## BIDDERS BULLETIN

**PROJECT:** Hitchcock Co. Schools – 2012 Addition and Remodel  
Culbertson and Trenton, Nebraska

BB-2

**DATE ISSUED:** January 26, 2012

| SHEET<br><b>ME100</b>       |

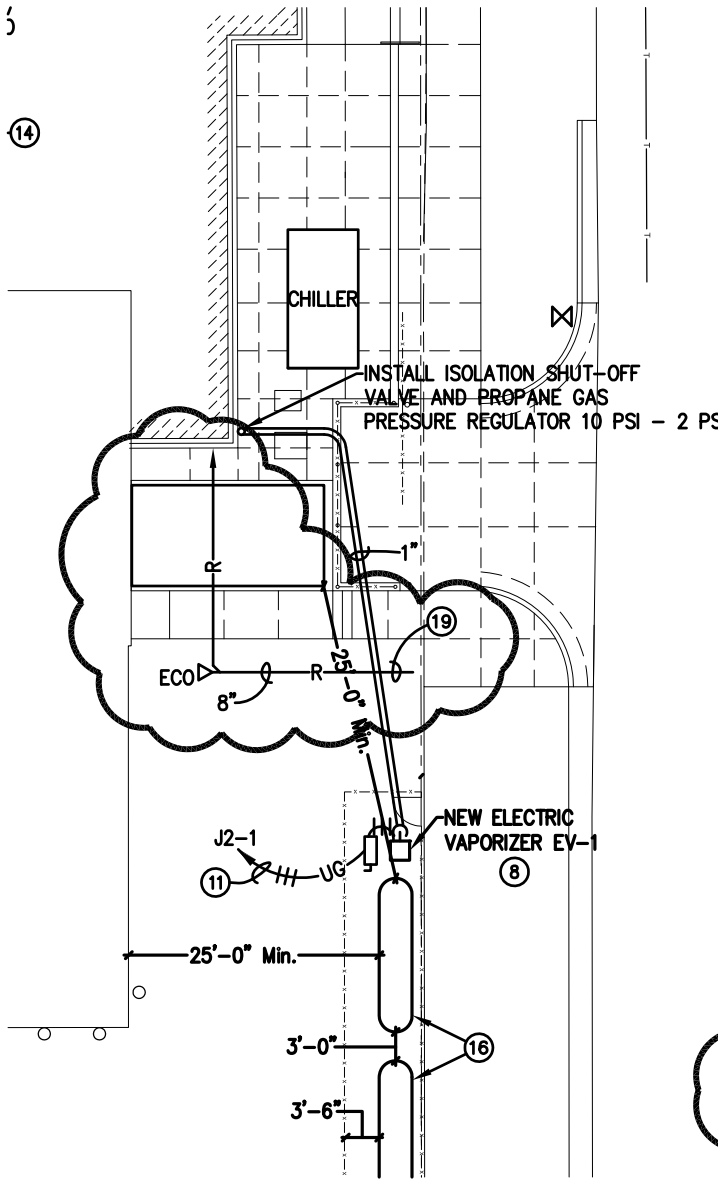
- 1. Sheet ME100 Mechanical/Electrical Site Plan
A. See attached drawing M1 for rainwater piping.
2. Sheet M200 Plumbing/Mechanical Plan – Area “A”
A. See attached drawing M2 for rainwater piping.

19. RUN NEW 8" RAINWATER PIPING TO NEW CONCRETE FLUME. SEE ARCHITECTURAL SITE PLAN. CUT PIPE OFF AT 45° ANGLE AND PROVIDE BIRDSCREEN.

E400

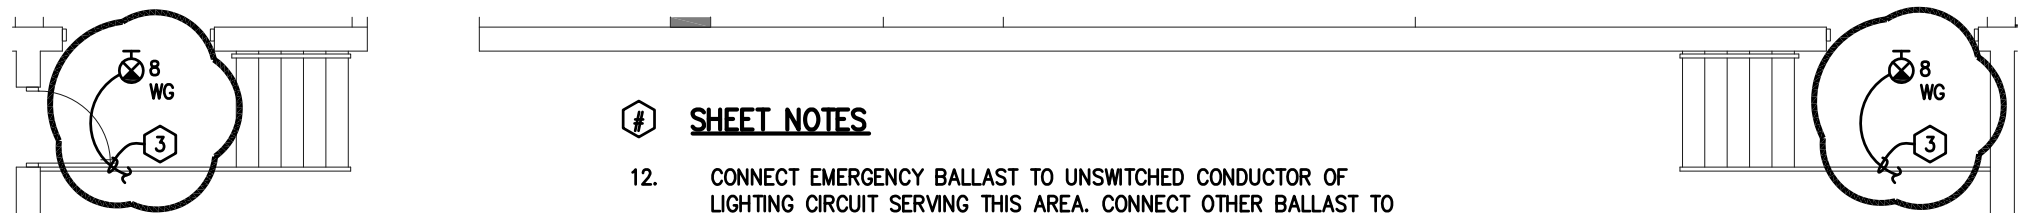
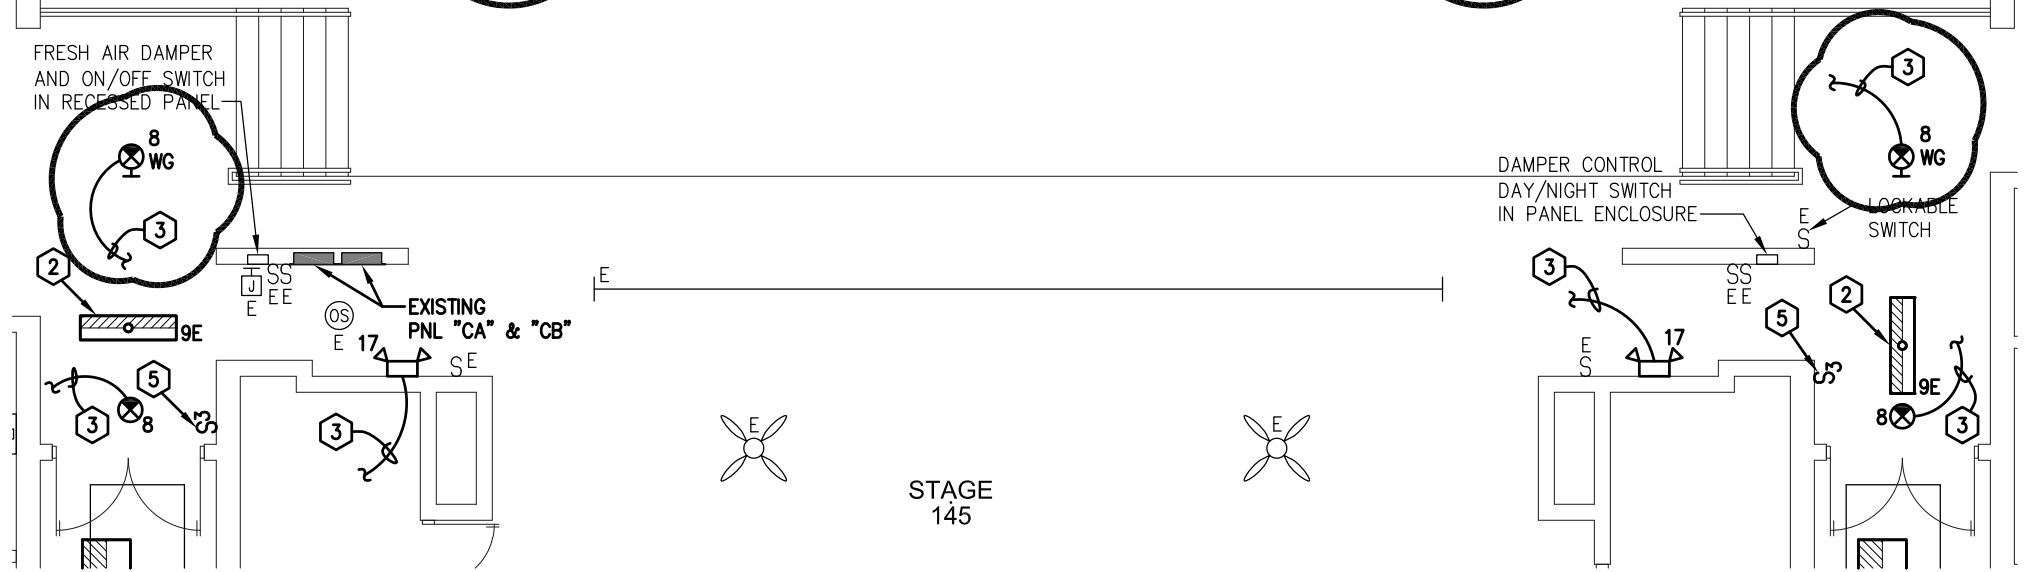
- A. Add a fire alarm speaker/strobe in large locker room in southeast corner of building.
4. Sheet E400, Electrical Schedules & Details
  - A. Light Fixture Schedule:

- i. Revise type #13, Lithonia FGB14-3-32-ACL-N1-X20U-MVOLT-GEB10IS-TCP-WG.
    - ii. Add type #13E, Lithonia FGB14-3-32-ACL-N1-X20U-MVOLT-GEB10IS-TCP-WG-EL14.

- iii. Add type #31E, Lithonia FGB14-2-32-ACL-N1-X20U-MVOLT-GEB10IS-TCP-WG-EL14.

PARTIAL LIGHTING PLAN - AREA "A"

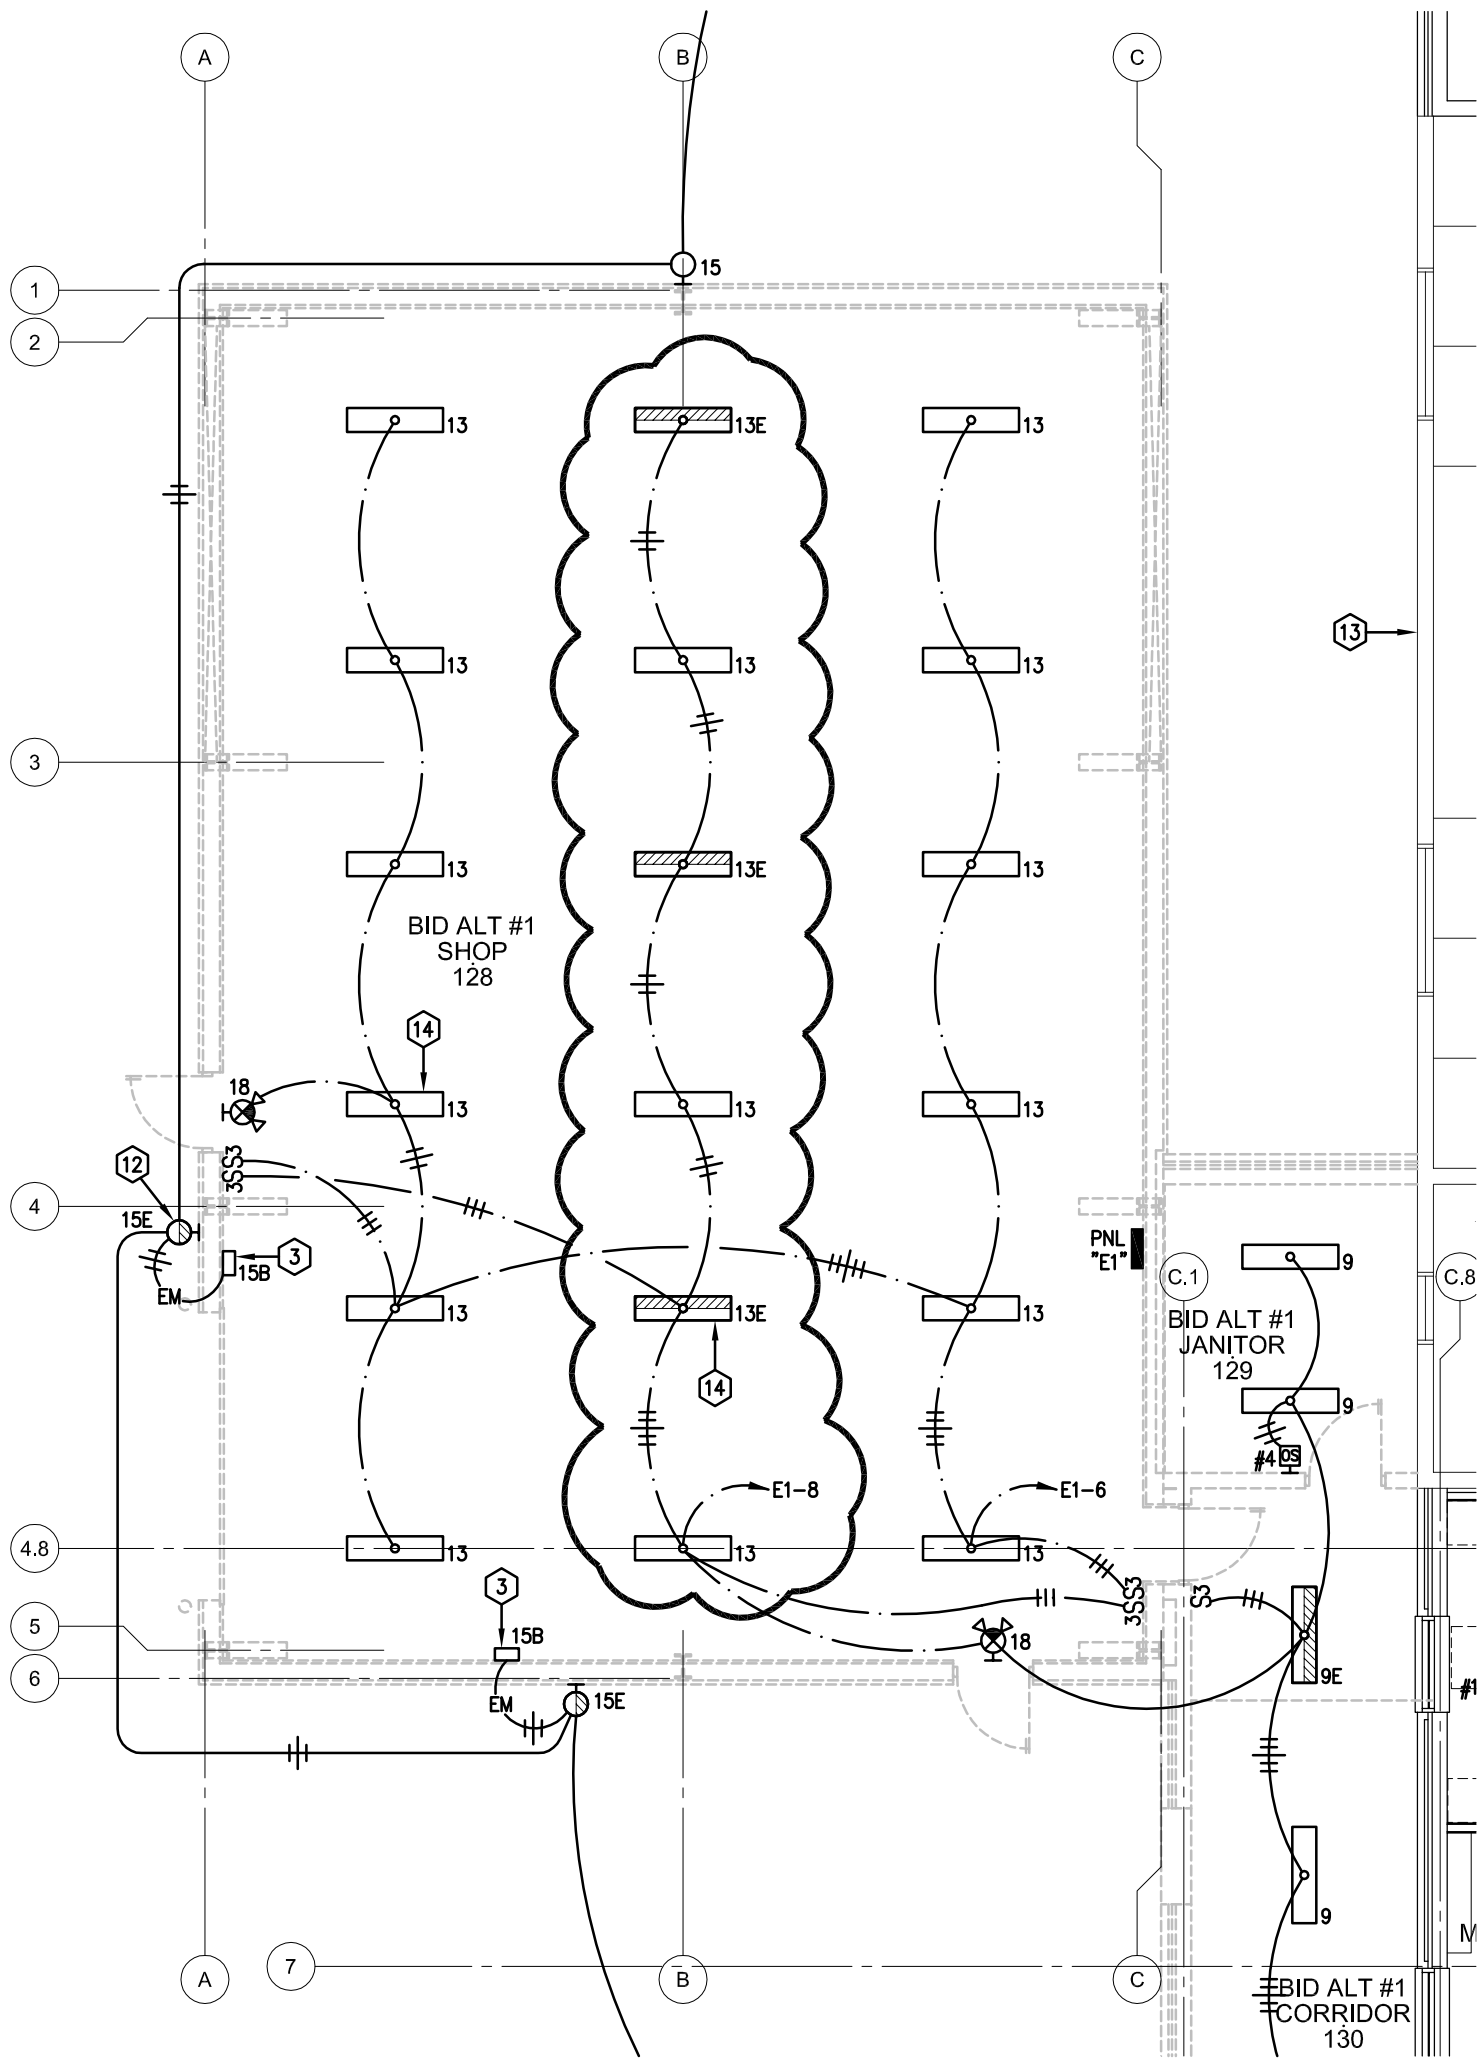
- C. Existing Gym:
    - i. Delete six (6) type 17 fixtures.
    - ii. Change type 18 exit lights to type 8.
    - iii. See attached drawings E4 for addition of type 31E fixtures.

12. CONNECT EMERGENCY BALLAST TO UNSWITCHED CONDUCTOR OF LIGHTING CIRCUIT SERVING THIS AREA. CONNECT OTHER BALLAST TO UNSWITCHED CONDUCTOR.

SHEET  
**E201**

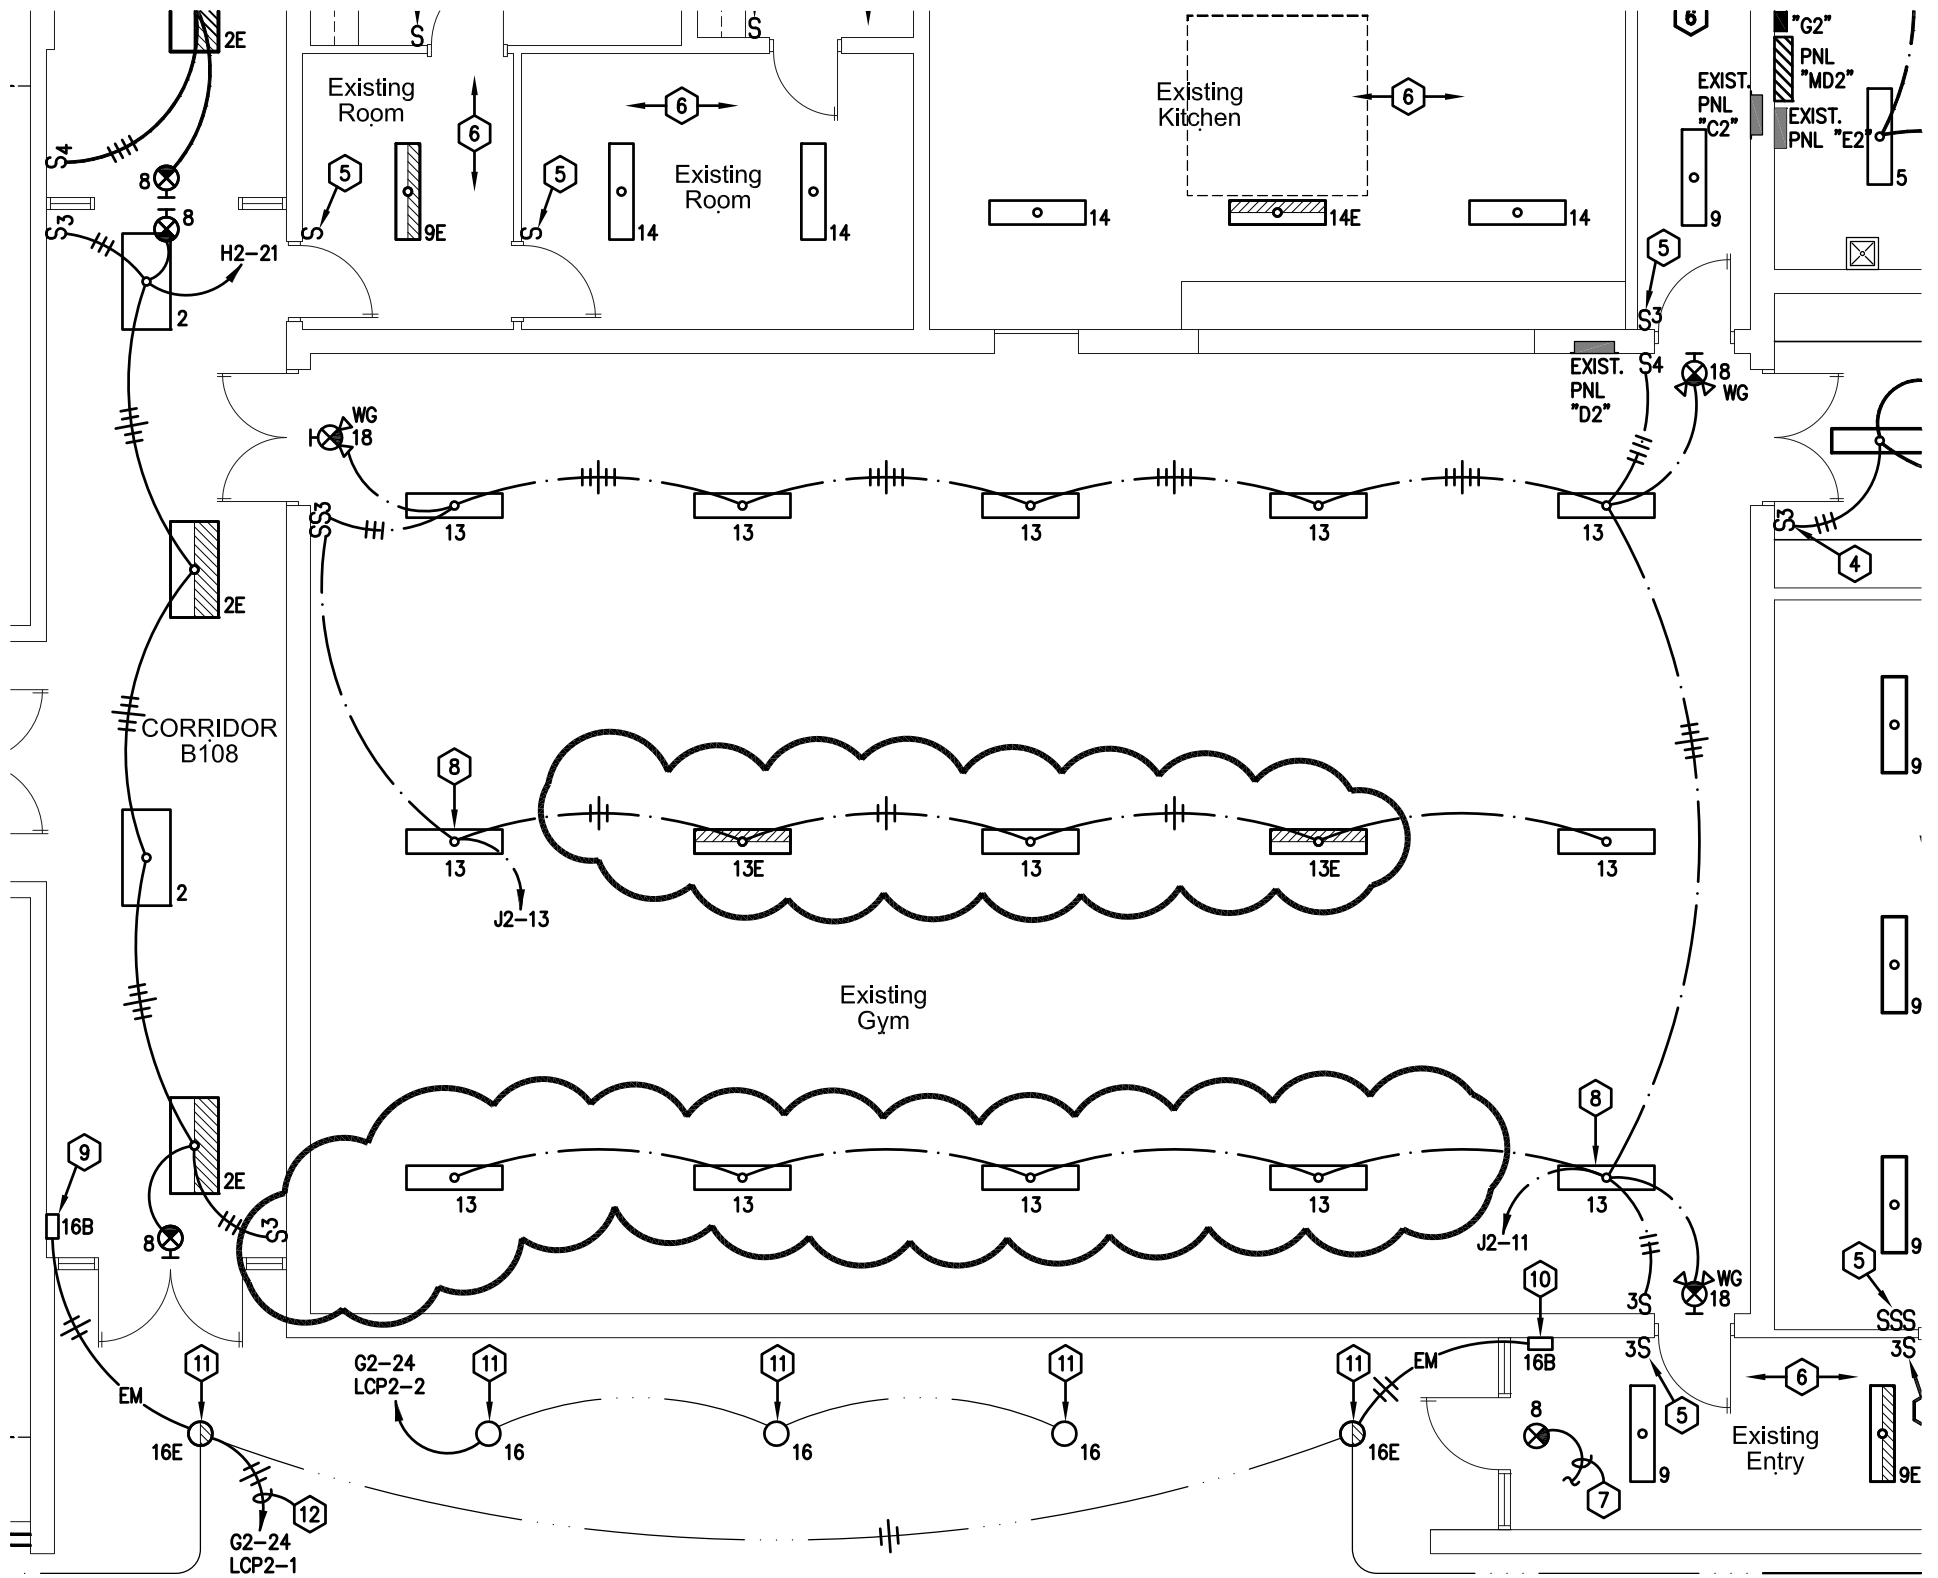
2. Sheet E201, Lighting Plan – Area “B”
  - A. Existing Gym:
    - i. Delete one (1) type 17 light fixture.
    - ii. See attached drawing E5 for revisions to ceiling mounted fixtures.

- B. Kitchen Rec./Dry Storage B110 – Rotate three (3) type 9 light fixtures 90 degrees, and mount as high as possible, below ductwork.
3. Sheet E300, Power Plan – Area “A”
